Access Design Assessment Report

Library & Community Hub

30-32 Miller Street  
Gilgandra NSW 2827

Project: Library & Community Hub, 30 - 32 Miller Street Gilgandra  
Document Type: Access Design Assessment Report  
Our Reference: P220\_458-2 (ACCESS) KG

Figure 1 – Pedestrian Entries

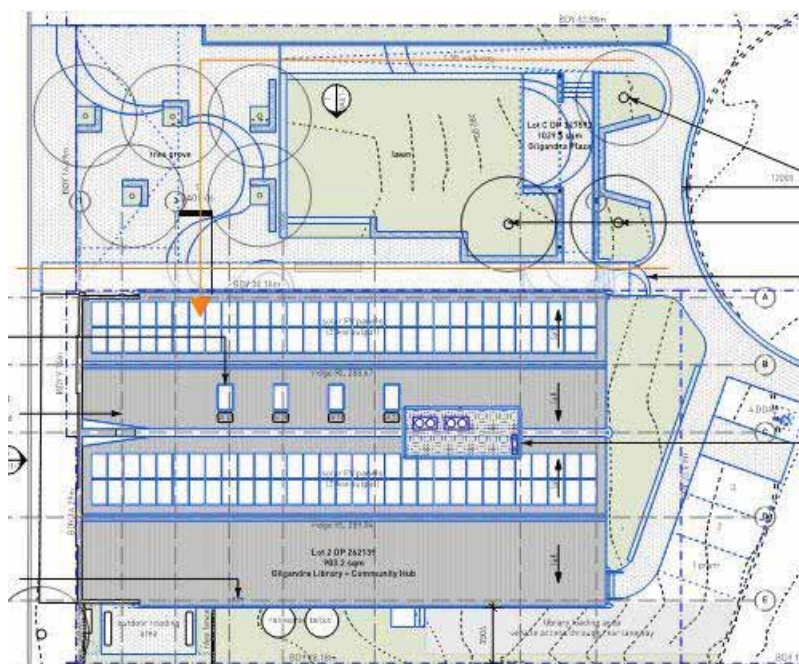
An accessways to Gilgandra Library and Community Hub is provided from Miller Street and from the rear of the library via a 1:35 walkway or stairways.

DESCRIPTION	COMPLIANCE DEPARTURE	RESOLUTION
Walkway 1:35	No levels provided for assessment of the walkway.	Provide RL levels on the drawings for further review and comment.
External Stairways	Stairways have not yet been detailed with all the required features and fixings.	Stairway to comply with AS1428.1-2009.  Level of detail provided is suitable for this stage. As design progresses, provide detailed drawings for review and comment.
Entry doors – Door circulation space	The entry doors are believed to be automated. In case the doors are not automated ensure appropriate door circulation space, compliant with AS1428.1-2009.	N/A
